9 Thanet Street
WC1H 9QL

Basement Impact Assessment
Audit

For
London Borough of Camden

Project Number: 12727-21
Revision: F1

DRAWING TITLE
PARTY WALL SECTIONS

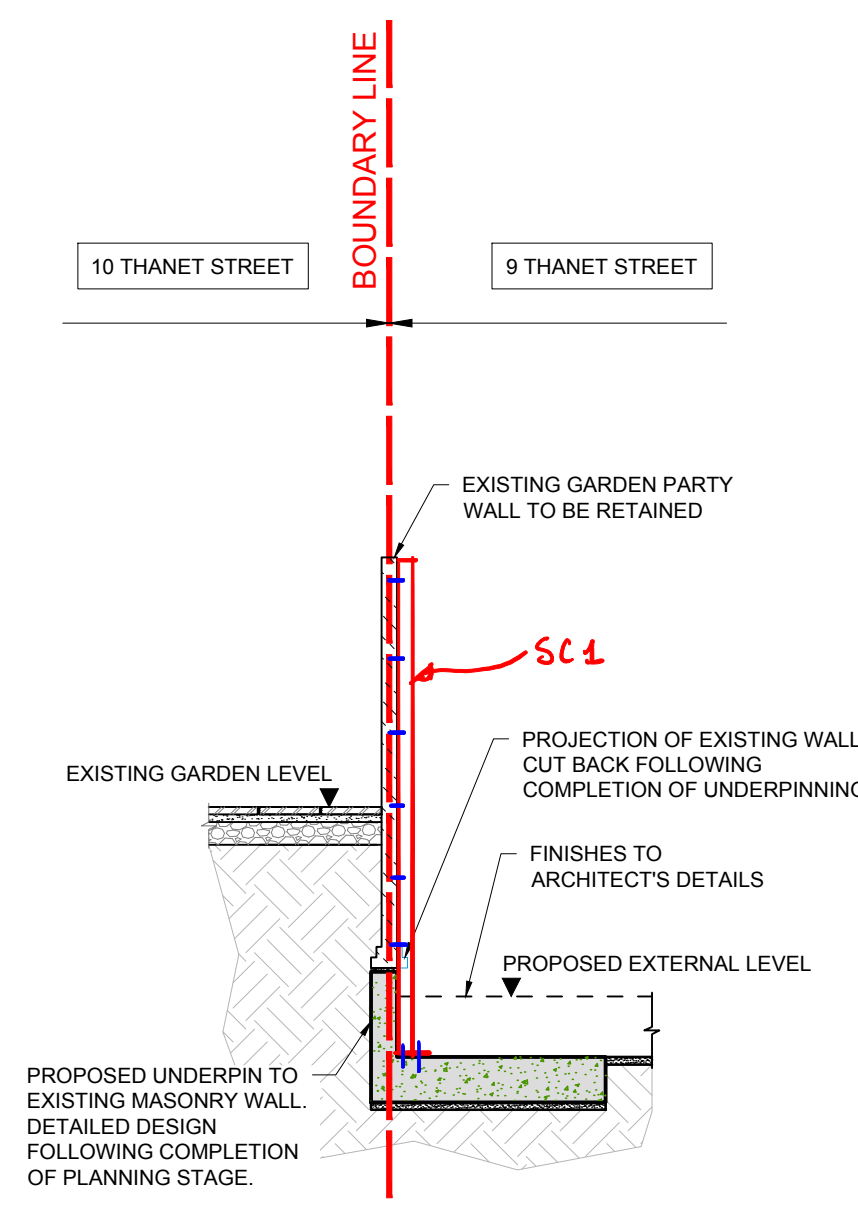
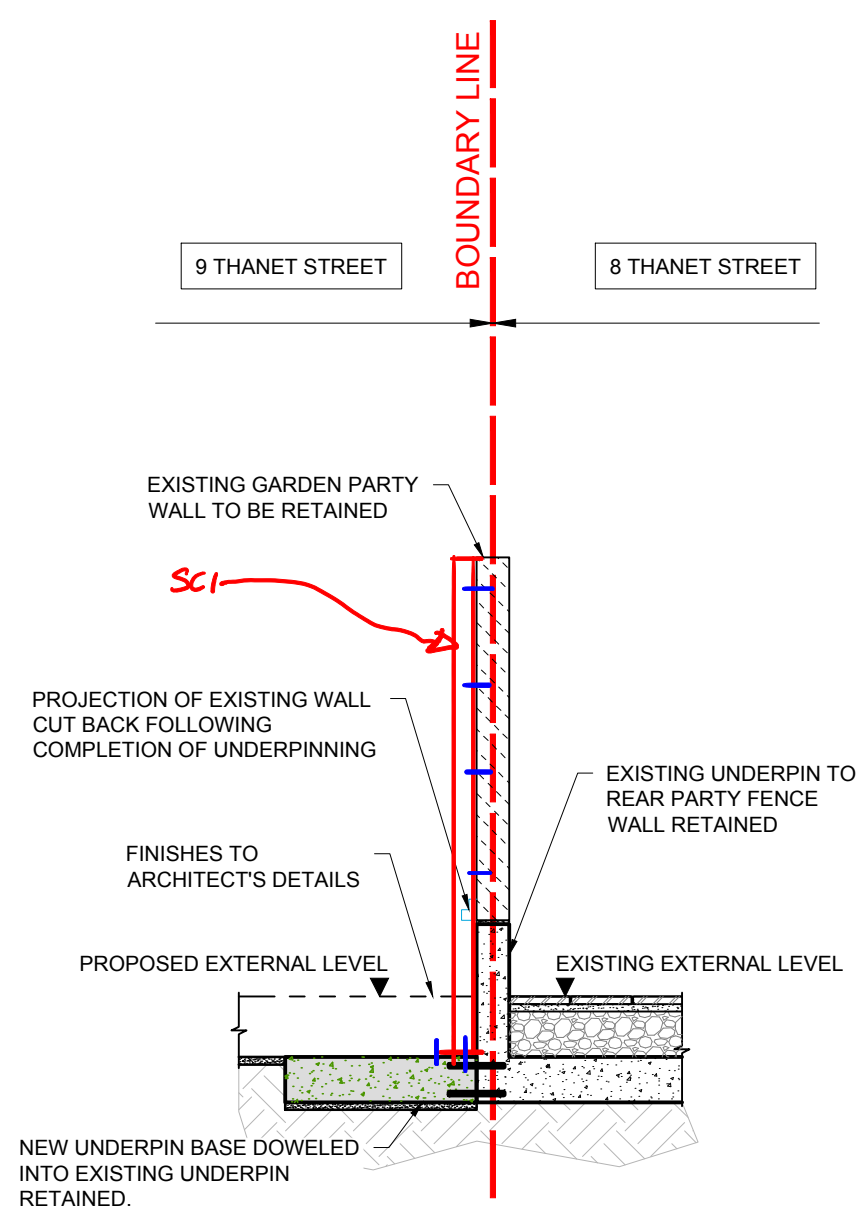
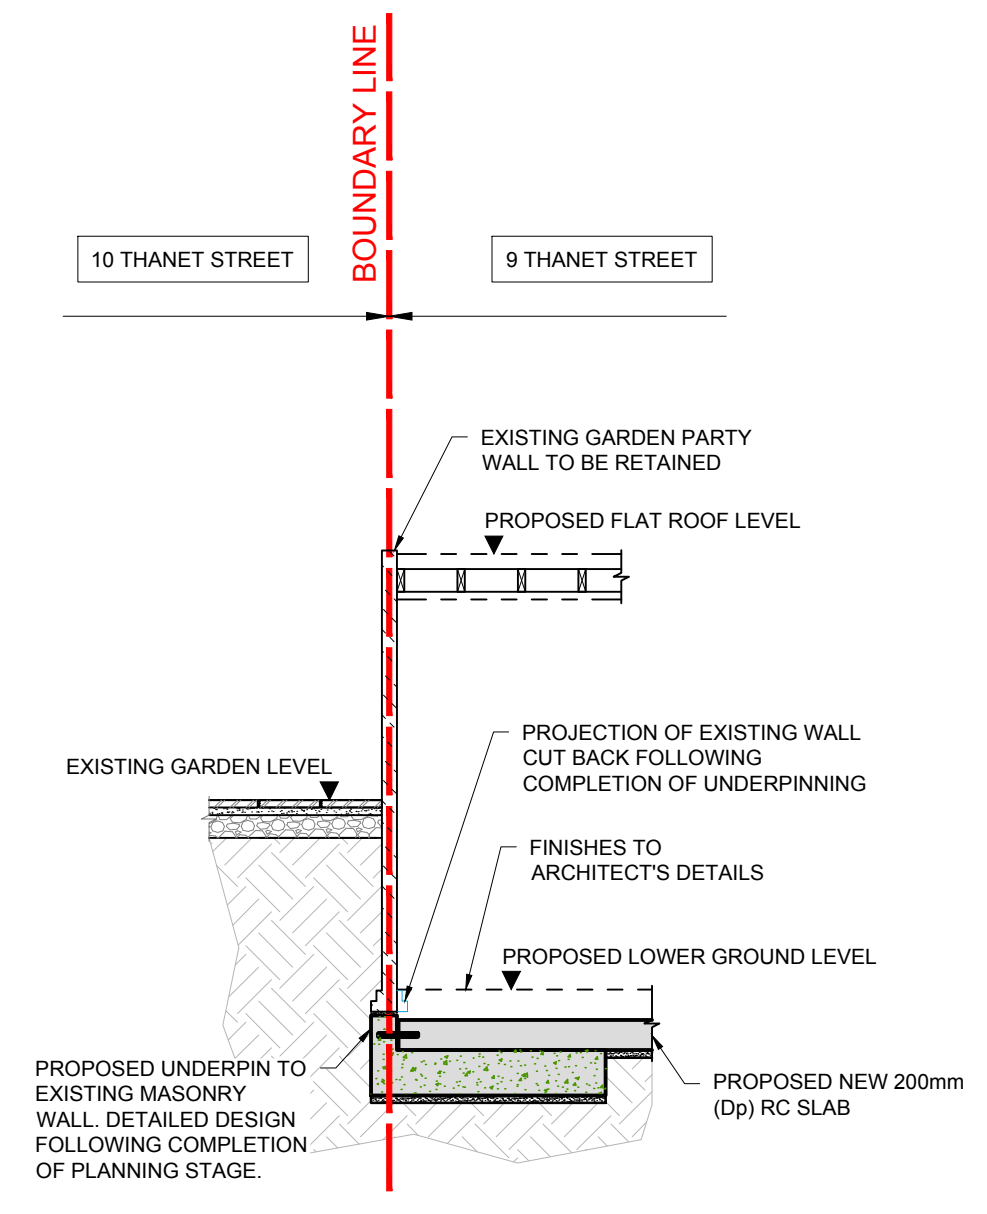
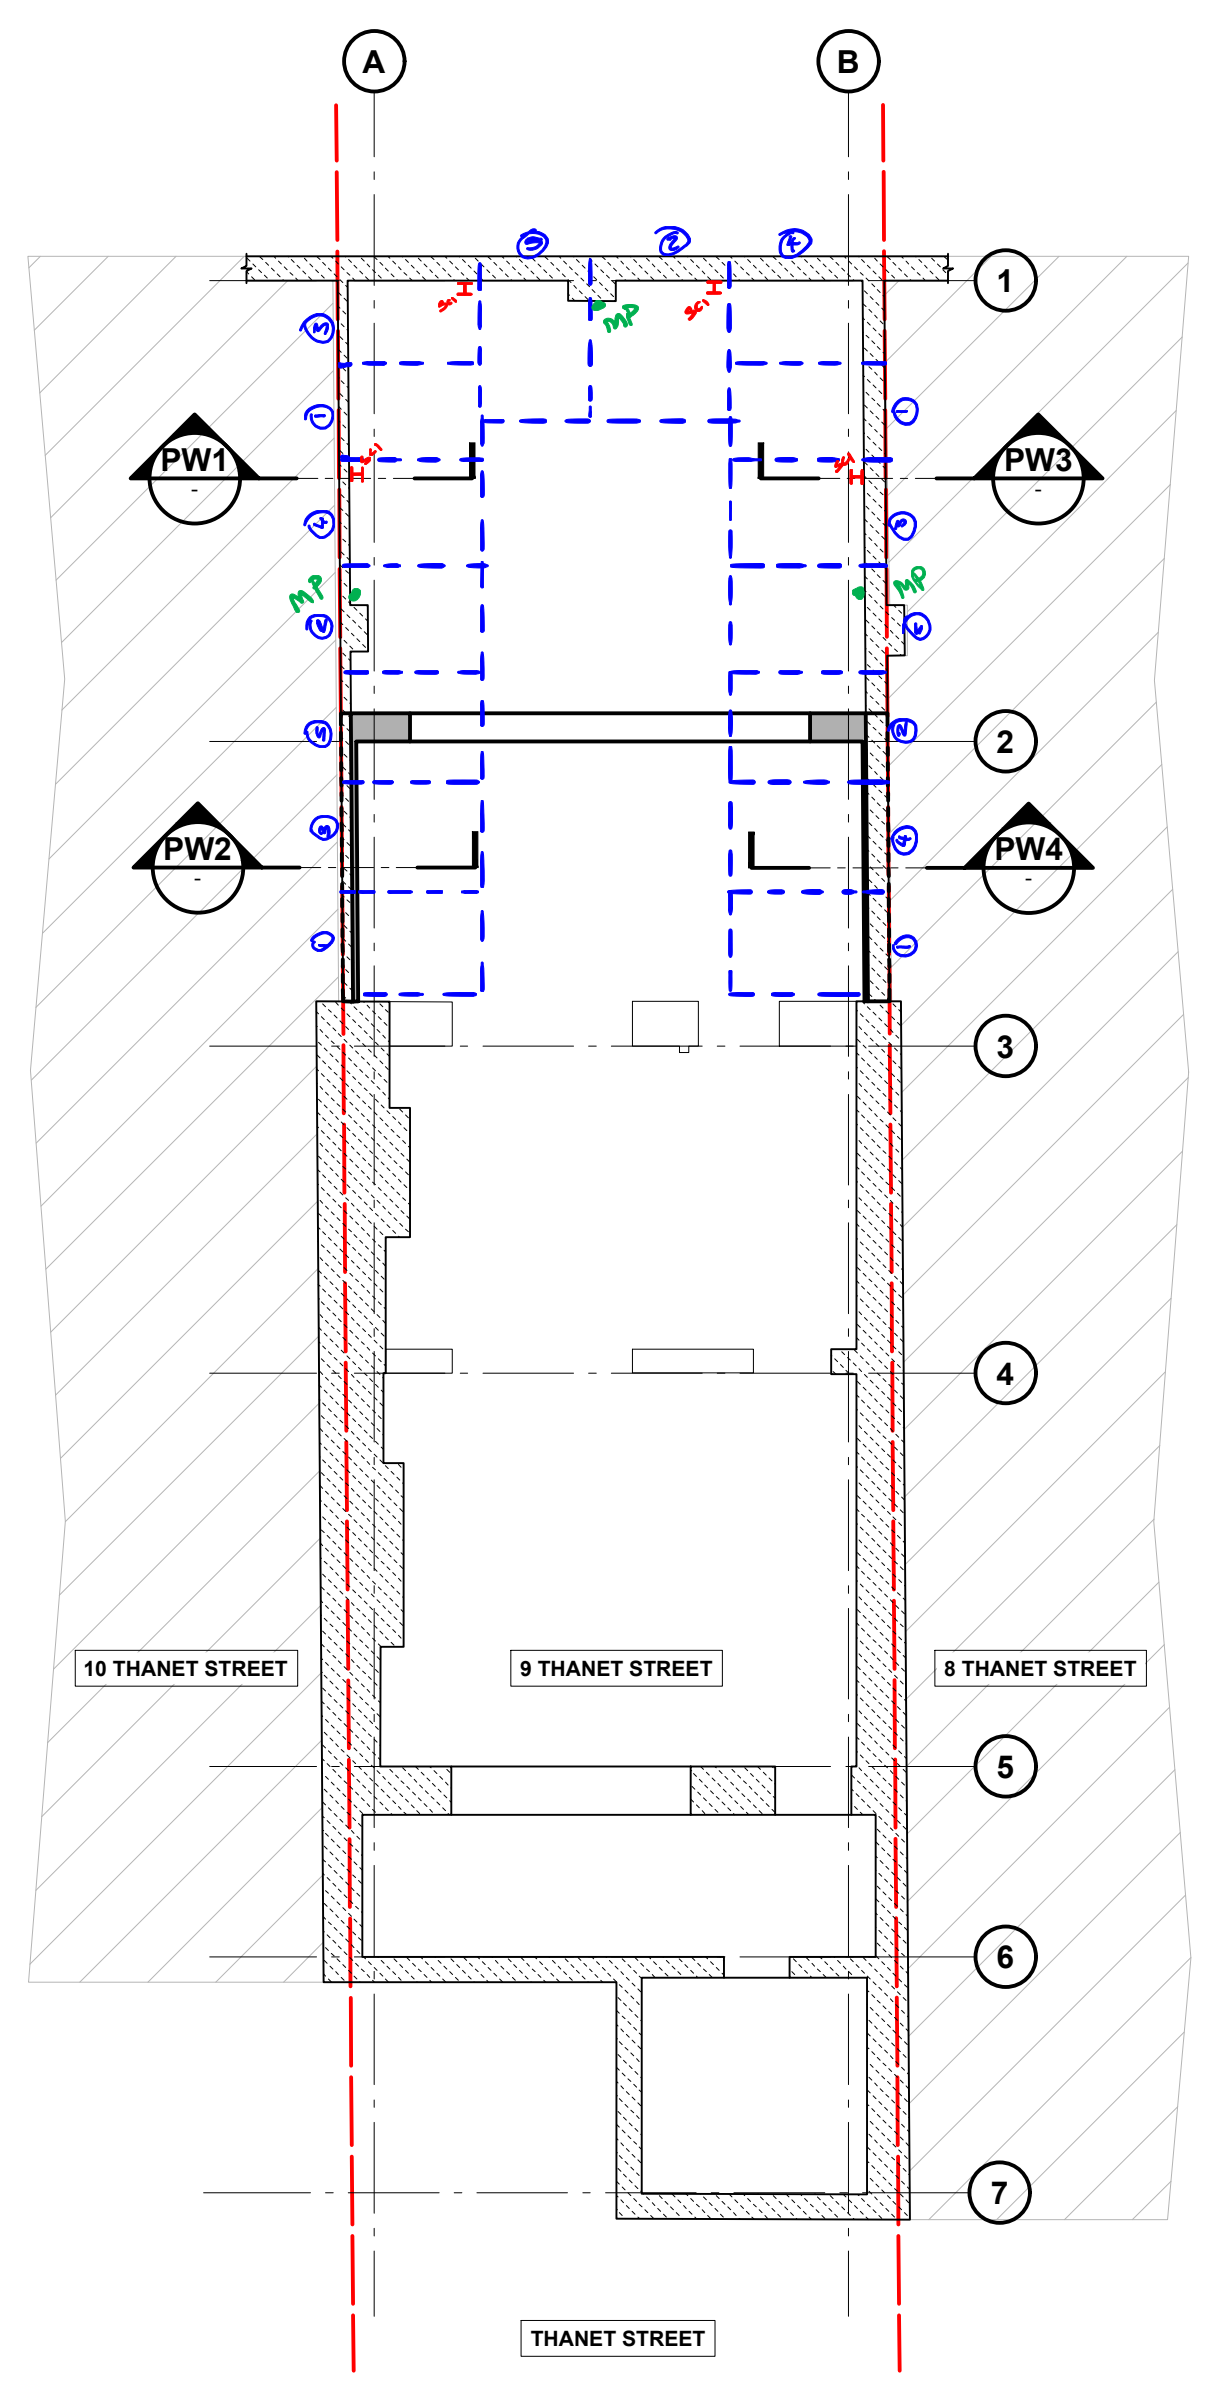
1. Please refer to attached 18837-S-2050 for marked up extent of underpinning to garden walls as requested.
2. Additionally as requested, please see attached outline methodology for the construction works.
3. Please refer to 18837-Sk7000 for outline temporary works scheme for the proposed works.
4. Movement monitoring location are outlined on Drg 18837-S-2050 and details included within the construction methodology.
5. Finally calculations for the underpins & SC1 columns – please note commentary below.

- 1.6. A supplementary drawing (Reference 18837-S-2050) shows the extent of underpinned foundation, and the additional information provides adequate justification for the stability of the host property and boundary walls being maintained during the proposed works.

PW2 SECTION
SCALE @ A1: 1:50
SCALE @ A3: 1:100

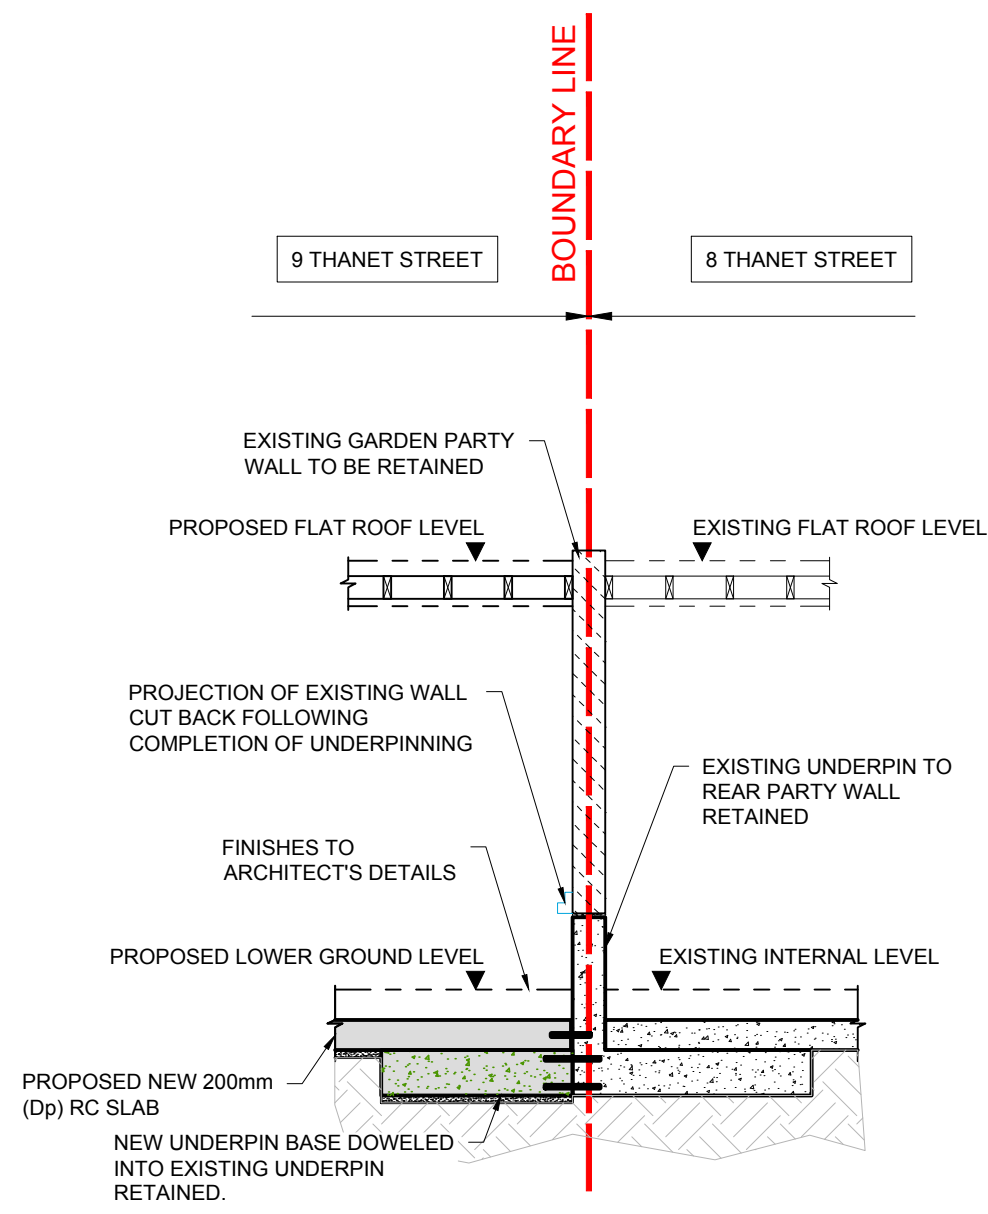
1. PW2 has been provided on Drg 2050, highlighted below, which has already been submitted, am I misunderstanding?

- a) please provide the section PW2 (sections PW1, PW3 and PW4 have been provided).
- b) since no site investigation has been undertaken, please confirm that the contractor will prove that the bearing formation has an appropriate insitu shear strength and state what that minimum acceptable shear strength will be.
- c) please confirm that the proposed works will limit damage to neighbours to a maximum of Category 1.

Thanks for the email - your responses do close out the remaining queries. In regards to section PW2, you did previously provide this drawing so my apologies.

**18837-Sk7000 - High Level/Low Level
Temporary Works Bracing Plan**

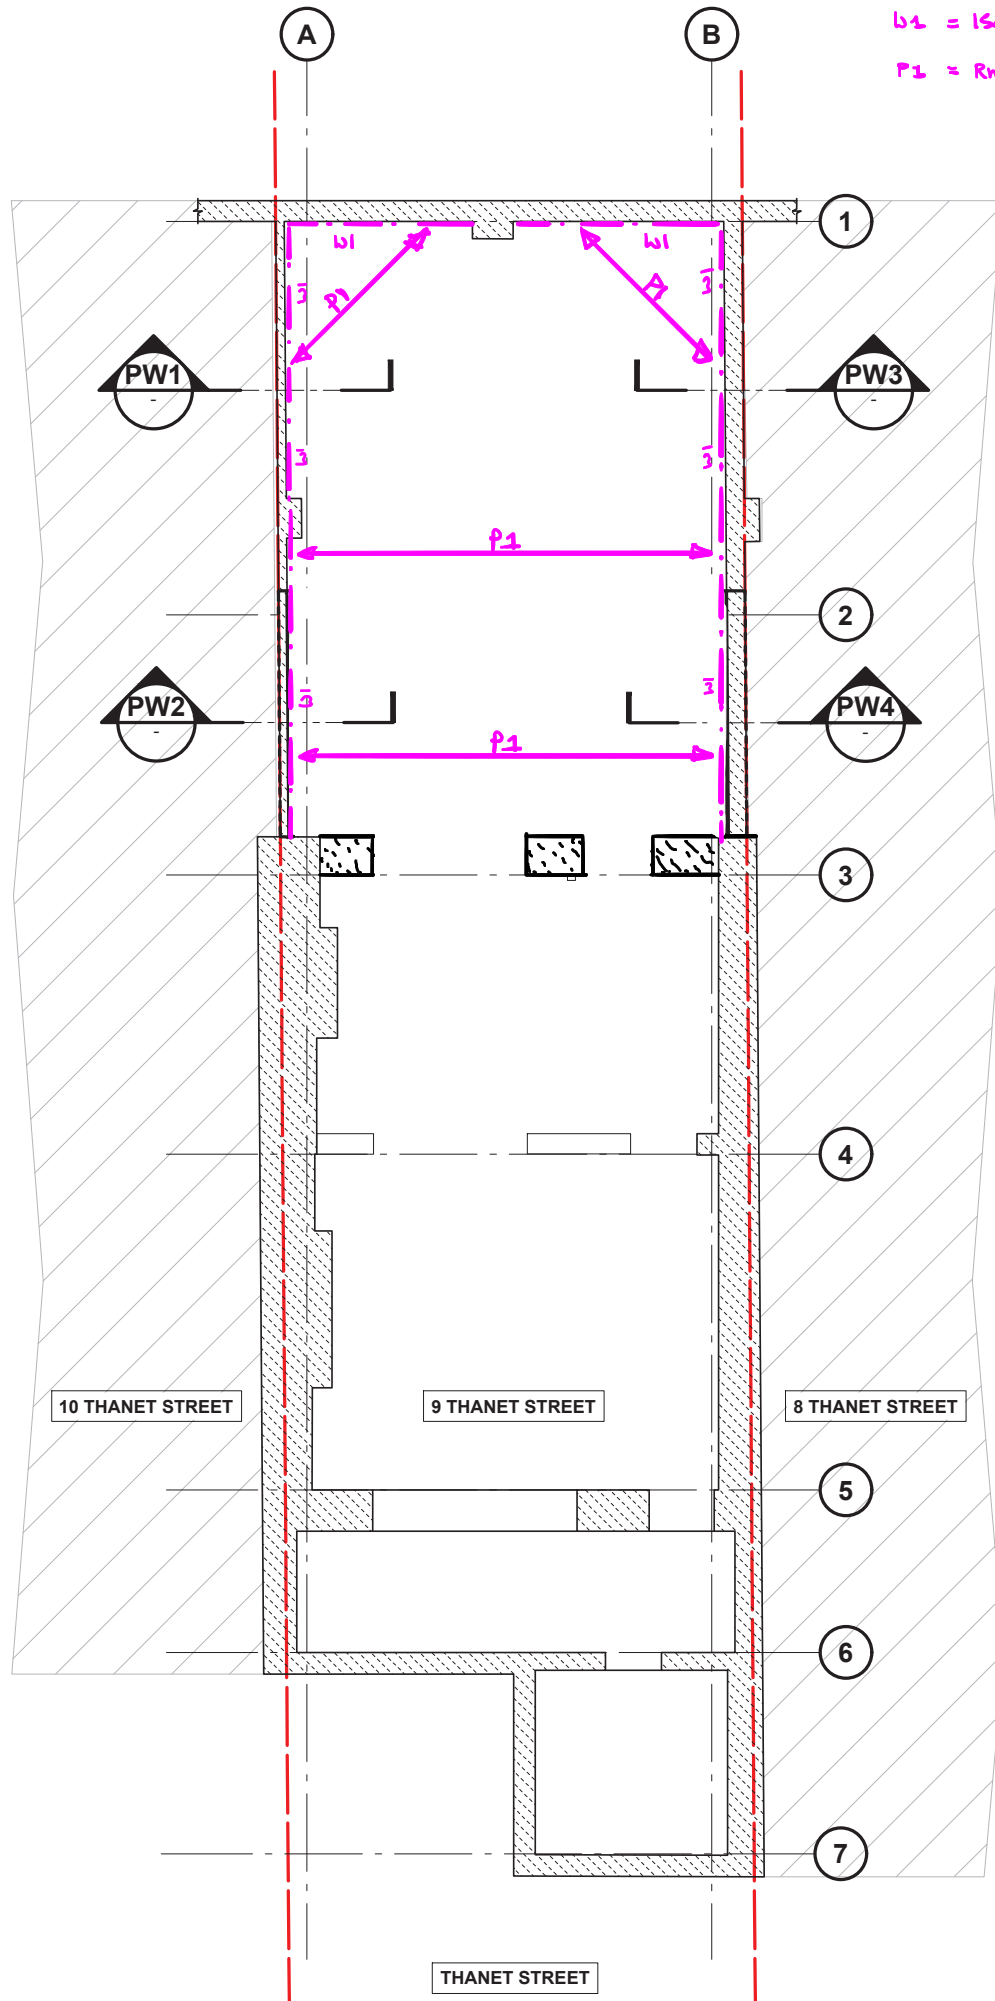
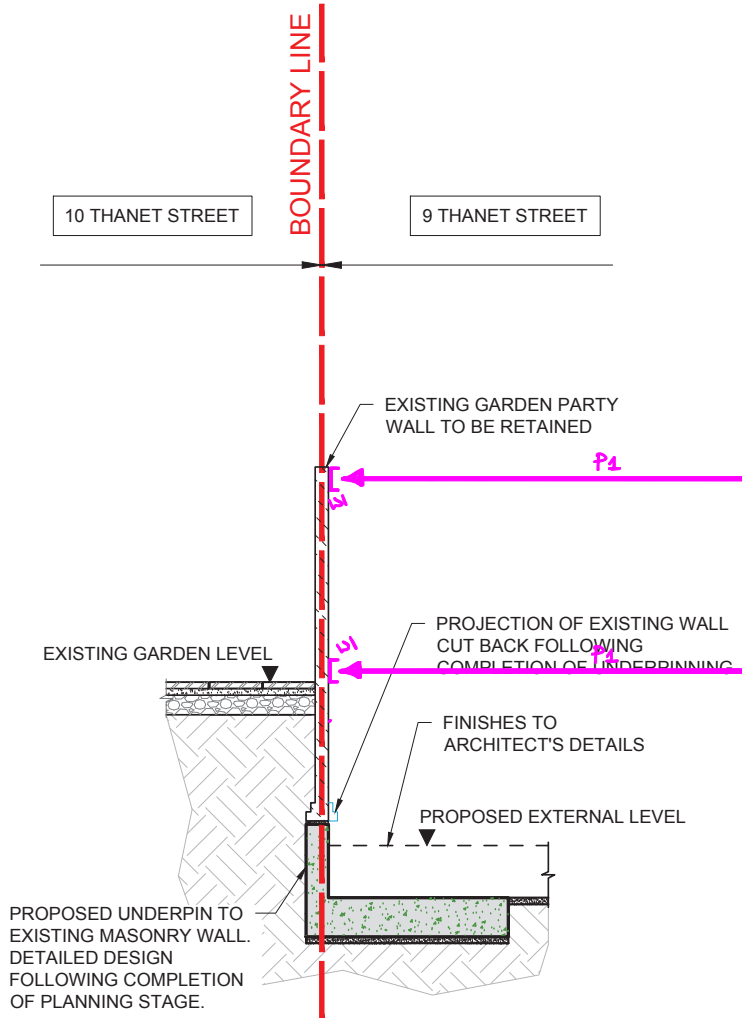
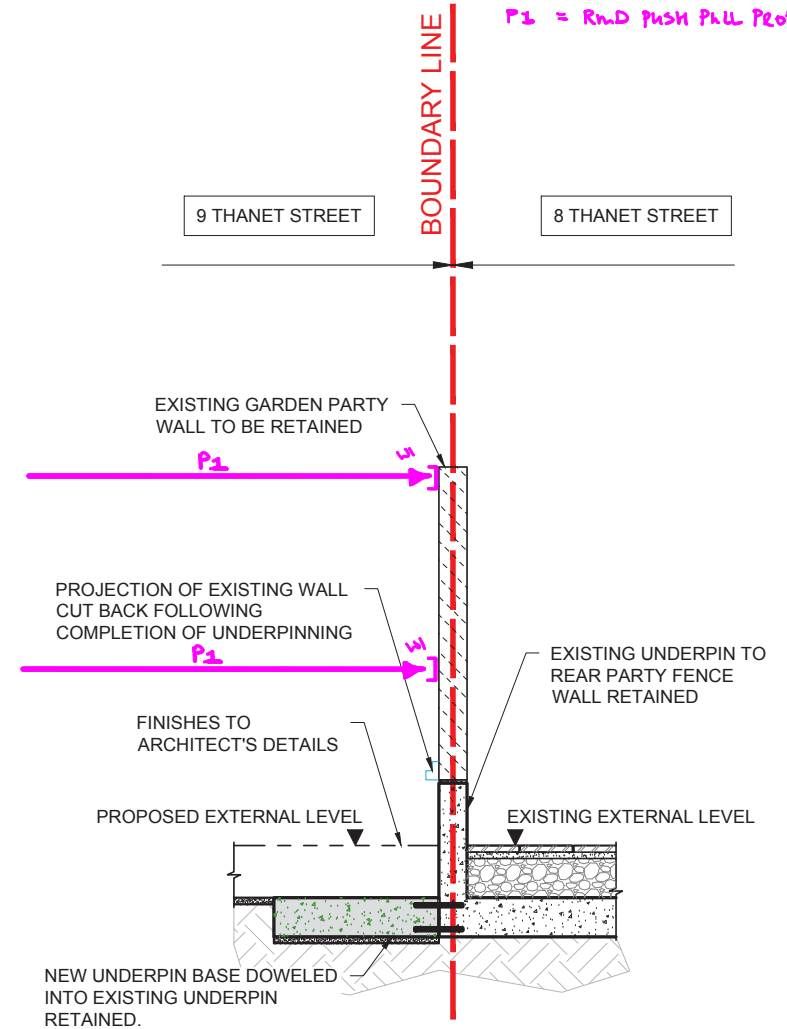
- Outline Methodology for construction works (prepared by Barden Chapman)
- Underpinning wall calculations (dated 07 February 2019, prepared by Barden Chapman)
- Party Wall Sections (Reference no. 18837-S-2050 (P1), prepared by Barden Chapman)
- Temporary Works Bracing Plan and Section (High Level/Low Level) (Reference 18837-Sk7000)

- 1.7. An outline temporary works proposal has now been provided along with calculations to justify the stability of permanent retaining walls for the remaining garden perimeter.
